Fermi 2 Power Plant NRC Docket No. 50-341 NRC License No. NPF-43

#### Subject: License Amendment Request to Revise Technical Specifications to Remove Obsolete Information, Make Minor Corrections, and Make Miscellaneous Editorial Changes

License Amendment Request to Revise Technical Specifications to Remove Obsolete Information, Make Minor Corrections, and Make Miscellaneous Editorial Changes

## 5.5.15 Surveillance Frequency Control Program

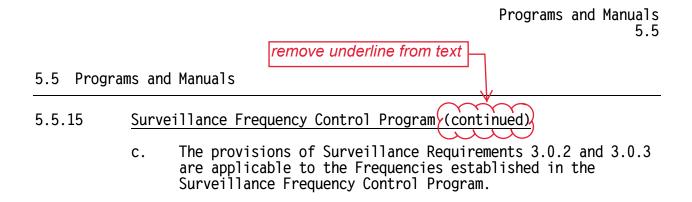
- TS Section 5.5.15 is split across two pages (pages 5.0-19a and 5.0-19b). The continuation notation at the bottom of page 5.0-19a should be moved to above the line to indicate that TS Section 5.5.15 continues on the next page. In addition, the continuation notation at the top of page 5.0-19b should have the underline removed to indicate that it is not part of the title of TS Section 5.5.15. These formatting issues were introduced when the Surveillance Frequency Control Program was revised in Amendment No. 218 (Reference 7.26).
